JUSTIFICATION

107 HIGH STREET, LINDFIELD, HAYWARDS HEATH, RH16 2HR

Proposed Ground Floor Plan

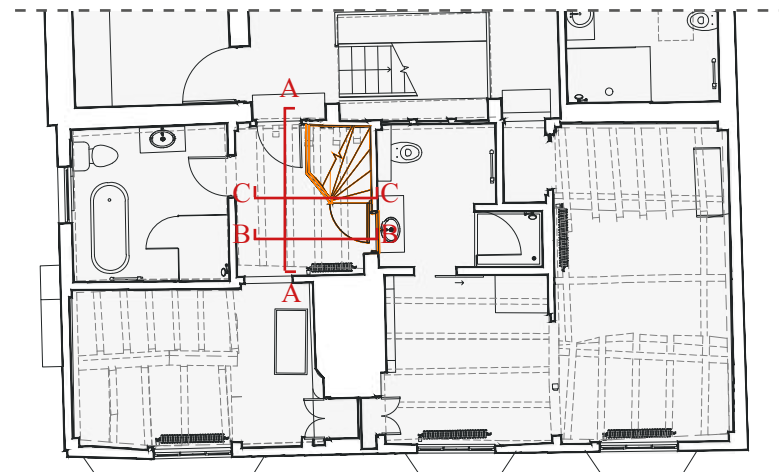
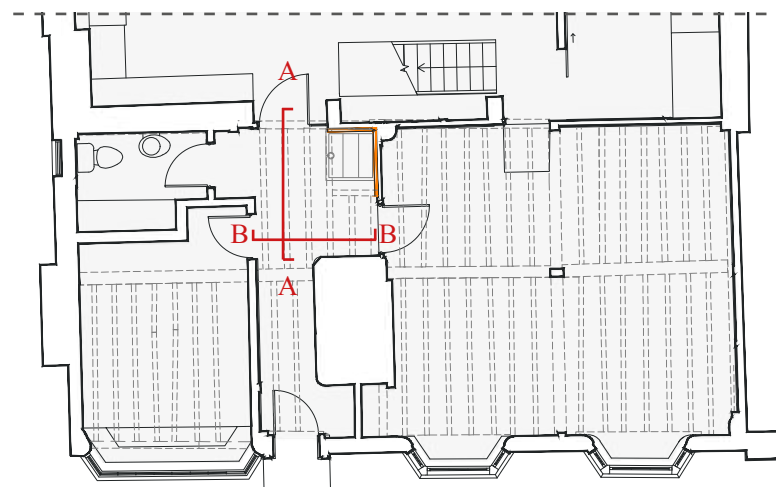
The historic, 17th century timber corkscrew winding staircase of historic value has been removed due to confusion arising in the approved drawings and conflicting information contained within them.

It is therefore proposed that the staircase will be reinstated on ground and first floor, as follows:

1. Ground to first floor staircase - the staircase outline is to be reinstated to create a reference of the historic feature. Refer to the proposed drawings for further details.

2. First to second floor staircase - the staircase is to be re-constructed without access to second floor to serve as shelving. Joinery to be built around with cupboard access door. Refer to the proposed drawings for further details.

1. Approved ground floor plan - submitted drawings under application DM/22/3694 & DM/22/3695 (planning approved)

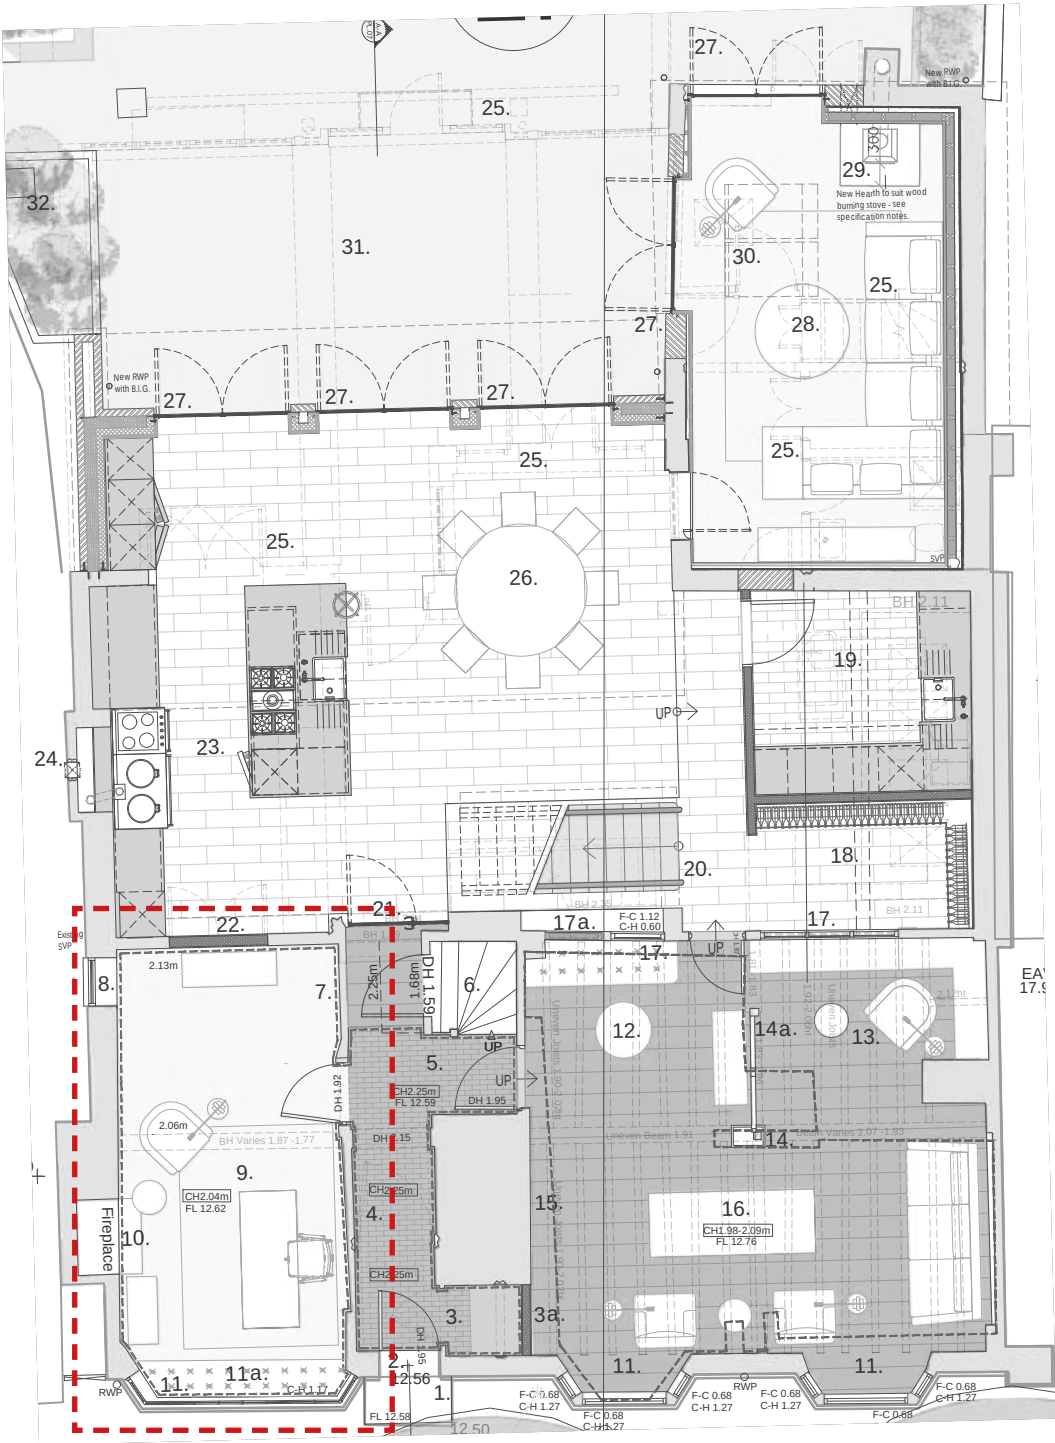
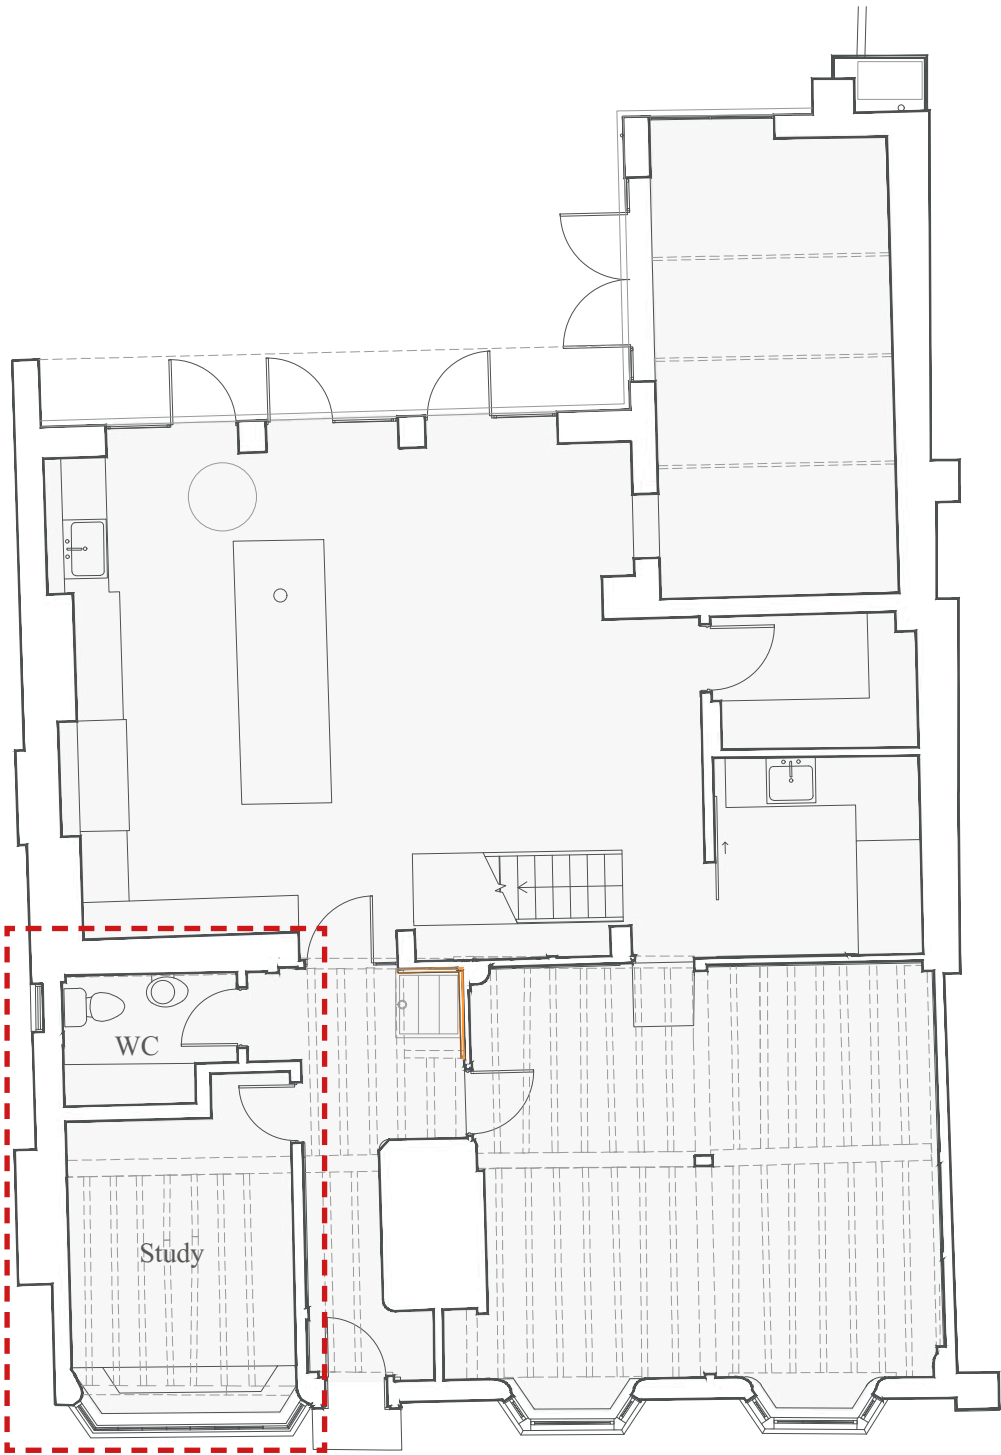
The approved documents and drawings contain conflicting information relating to this aspect of the scheme; the approval notice makes written reference to the inclusion of a ground floor WC, whilst the drawings do not.

A partition wall was constructed in the southern part of the ground floor plan to accommodate a new ground floor WC. Furthermore, a timber stud wall with stone veneered nogging at ground level was removed to create a reveal / recessed entrance to WC. In their report HCUK assessed this as follows: *‘It appears not to have been an original wall or historical feature, as demonstrated by the presence of concrete blockwork within the wall uncovered during its removal. The demolition of this partition to create a reveal / recessed cloakroom at the entrance to the ground floor WC improves circulation and layout without harming significance. The impact of this change on the listed building’s significance would be a minor heritage benefit as the wall was misleading and interruptive of historic plan form.’*

This is a deviation from the approved scheme and is part of the retrospective works that this application applies for.

Ground floor plan approved under application LF/064/87

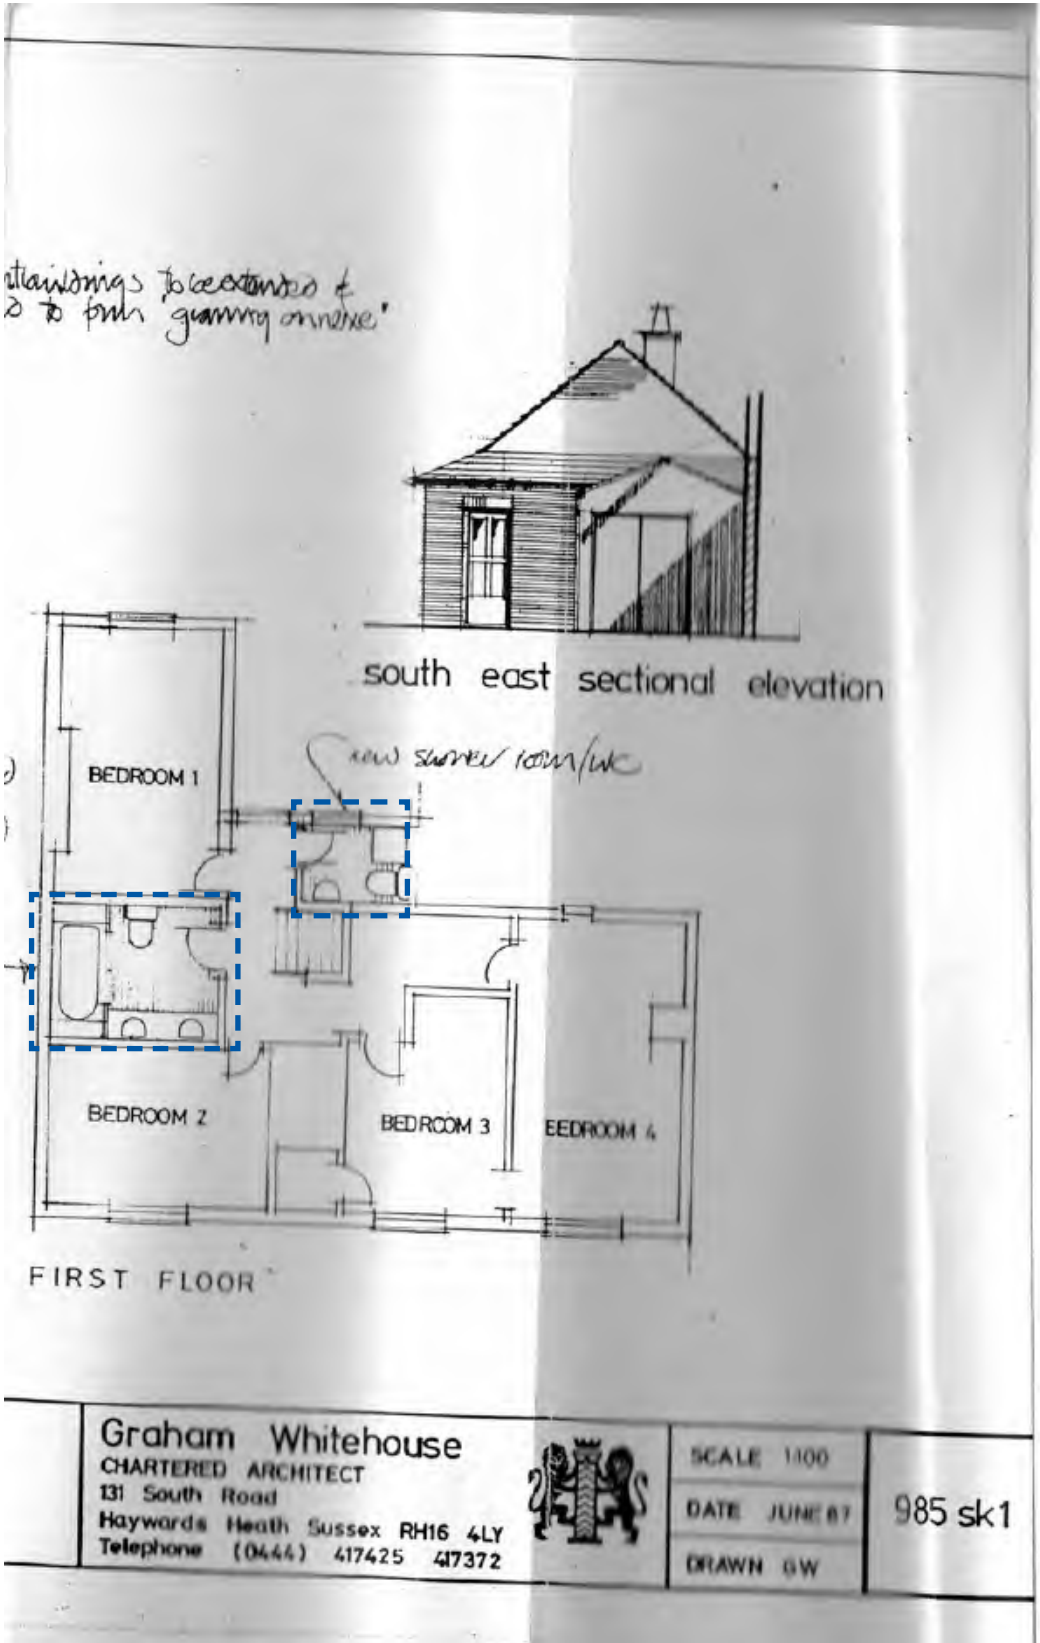
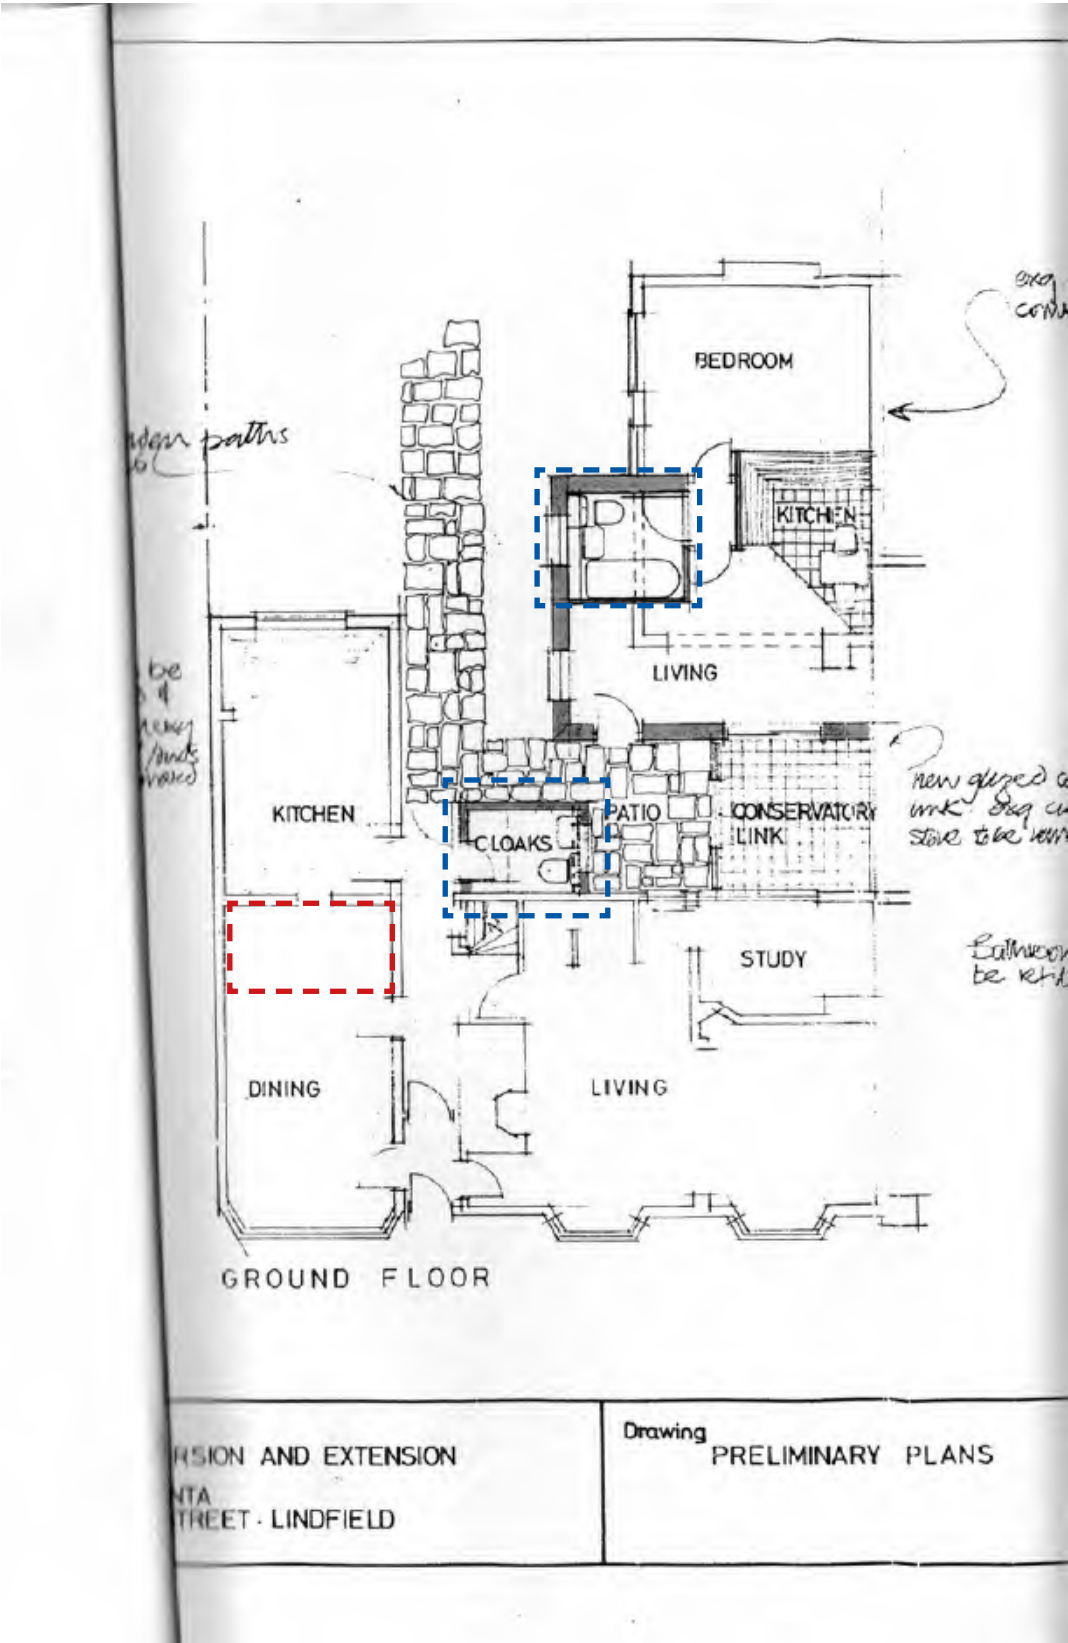
The addition of cloaks/WC on a ground floor has been previously approved under application LF/064/87 in 1987. The WC extension was demolished following approval of application LF/83/96 granted on 09/01/1997 for: '2 storey rear extensions and demolish 2 storey rear extension housing WCs.'

It is also noted that historically this four bedroom house was provided with 4no. toilets/bathrooms - two per floor. Currently, the building has 2 bedrooms with en-suites and one shared bathroom on the first floor. A small WC was added on the ground floor deviating from approved scheme. However, the re-introduction of a ground floor toilet ensures the building is accessible and usable for everyone, regardless of their physical abilities. It is considered to be an essential improvement.

The door to the study is in the same historic location it was, just re-handed within the frame to better suit the revised layout. The new dividing wall has been constructed of lathe and lime plaster construction, using traditional methods and materials. Secular character of the historic plan is retained.

2. Proposed ground floor plan

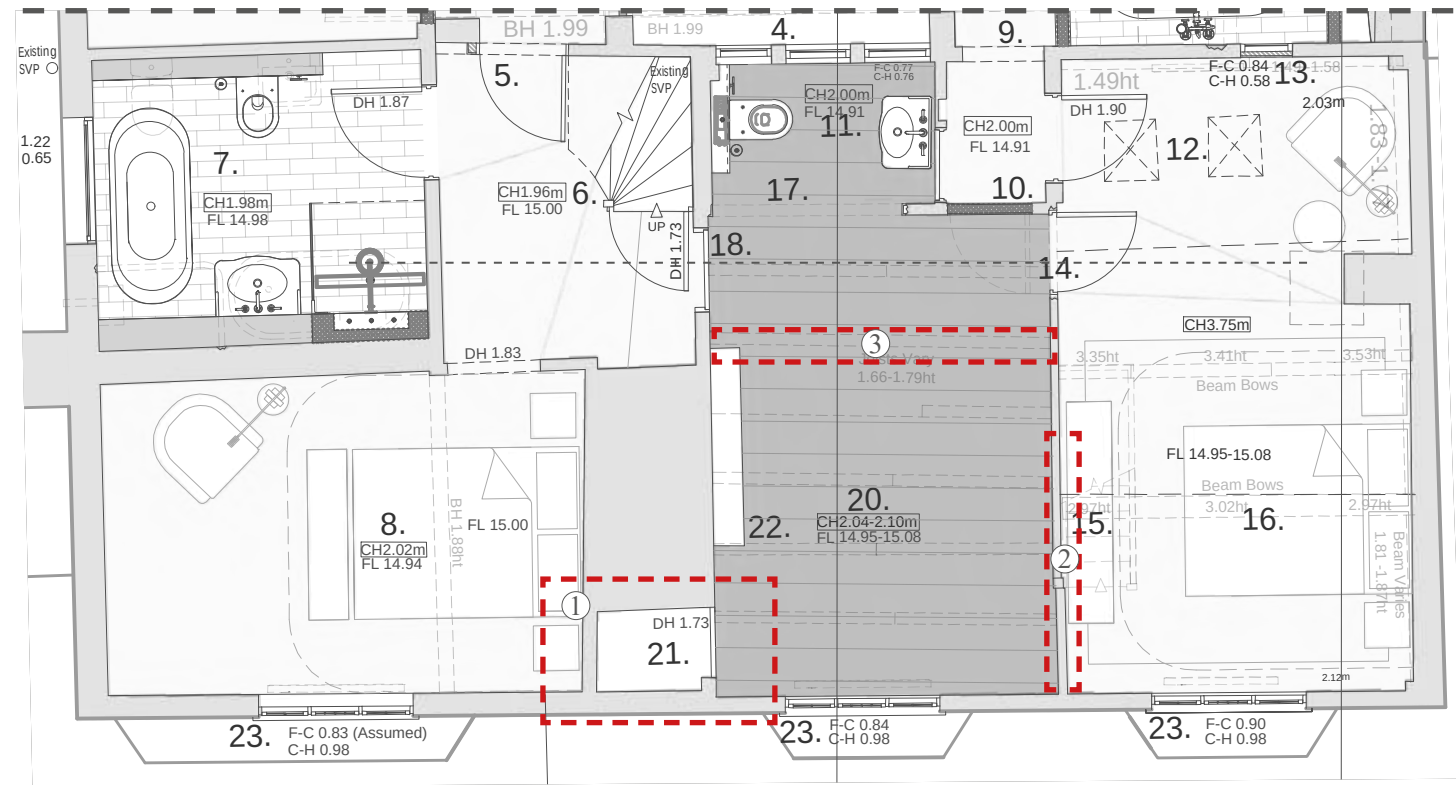
1. FITTED WARDROBES

Installation carcasses and MDF doors to create 2no back to back wardrobes, serving 2no bedrooms. Wardrobe doors designed to follow the shape of the chimney. This is a minor deviation from the approved scheme proposing one wardrobe and minor modification to the previously existing wardrobe.

2. REMOVAL OF WALL

The non-original infill to partition wall between two rooms was removed, the addition of doors was not implemented. Original timber frame retained.

3. WALL AND DOOR TO BATHROOM

Removal of existing, poor quality wall and construction of new partition wall, reinstatement of sliding door to en-suite.

These deviations are considered to be of limited harm and are applied for retrospectively under this application.

3. Approved scheme rear elevation.

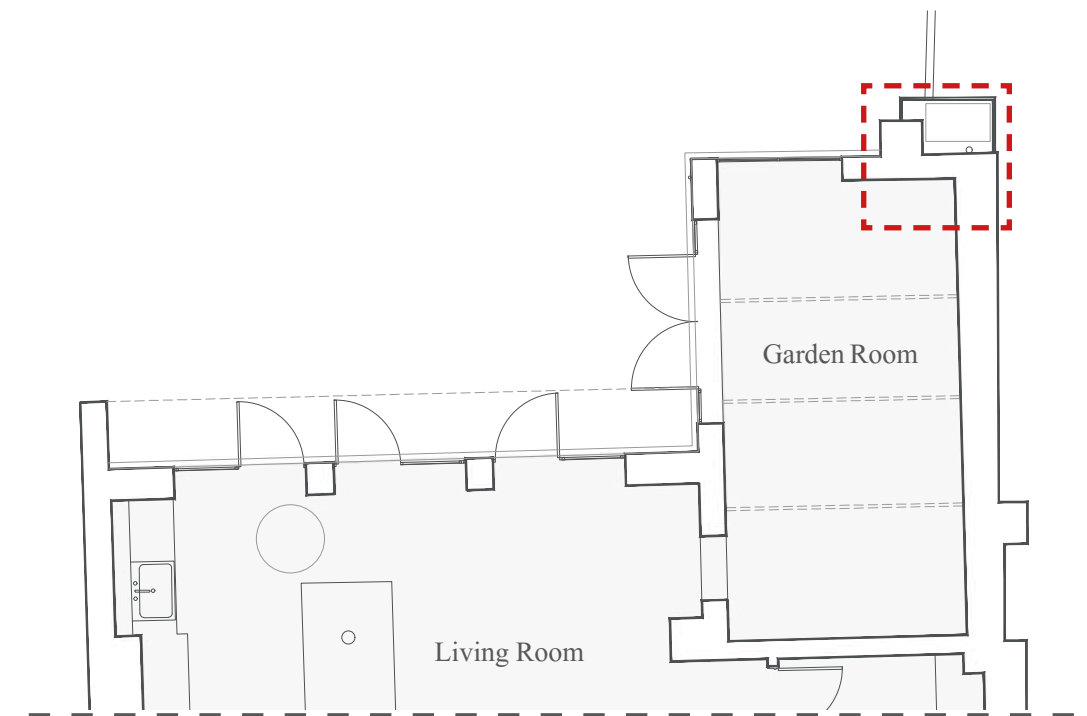
A new timber louvred enclosure accommodating AC AHU equipment has been constructed, adjacent to the bake house rear elevation. It was constructed without planning permission and is a part of retrospective works applied for under this application.

The enclosure is discreetly located in the corner of the elevation and constructed of timber in-keeping with the whole building style.

As shown on adjacent elevations, the approved scheme established a permanent fixed mass in front of the bakehouse in the form of a raised brickwork planter.

1. Approved West Elevation - submitted drawings under application DM/22/3694 & DM/22/3695 (planning approved)

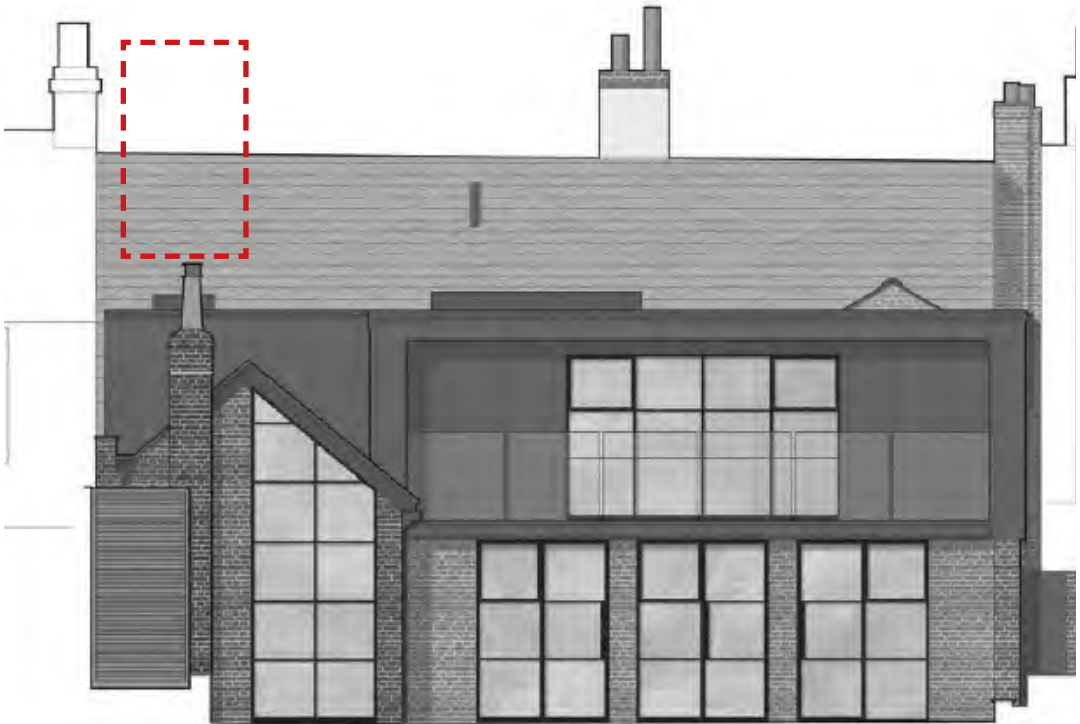
A 19th century chimney stack has been removed without planning permission and is a part of retrospective works applied for under this application.

Its removal is considered of to be of low harm to the listed building, as identified by HCUK in the supporting heritage statement.

The existing chimney stack was in a poor structural condition, as quoted below from ‘Statement of Heritage and Significance’ by Desbruslais:
